# SFO ALUCP Consistency Review

Genentech Master Plan Update

#### Genentech Master Plan Update

#### Airspace Protection – Structure Heights

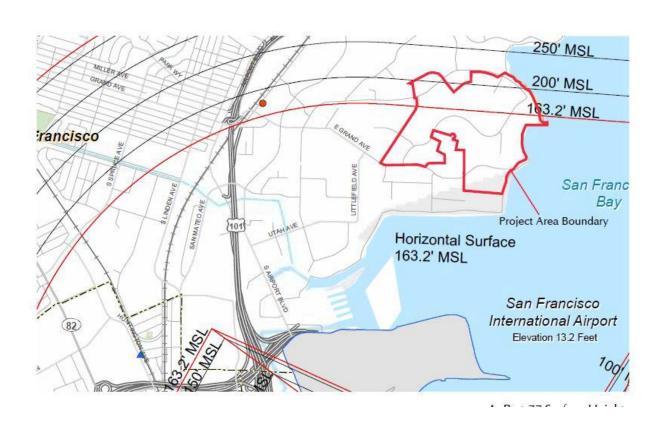
- FAR Part 77, Objects Affecting Navigable Airspace establishes height restrictions and FAA notification requirements
- Genentech MP and Zoning reference these requirements for building heights.
- Construction-related activities are not clearly addressed condition recommended:
  - Language to be added to Genentech MP Zoning to address potential construction related impacts that may require FAA notification
